## **SB-0365**

### **Insider – Ventless Donut Kiosk**

**Subject: Proper System Installation and  
Inspection of Control Heads.**

**Bulletin Number:** 2323

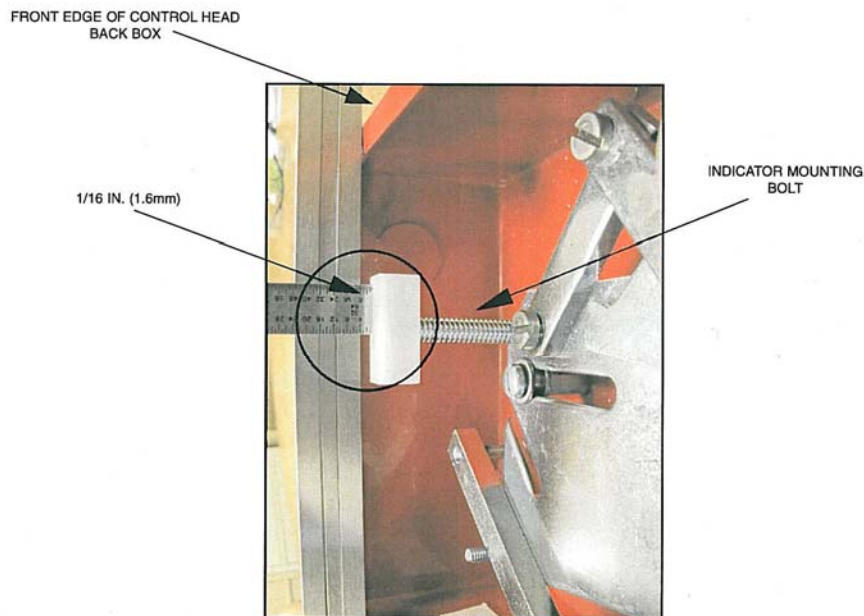
The system should be checked to make sure the white indicator tab is not binding on the cover assembly. Binding could cause the system to be inoperative.

If binding is occurring, the following corrective action should be taken:

As shown in the diagram below, turn the indicator mounting bolt until you have 1/16 in. (1.6 mm) clearance between the front edge of the control head back box and white indicator surface.
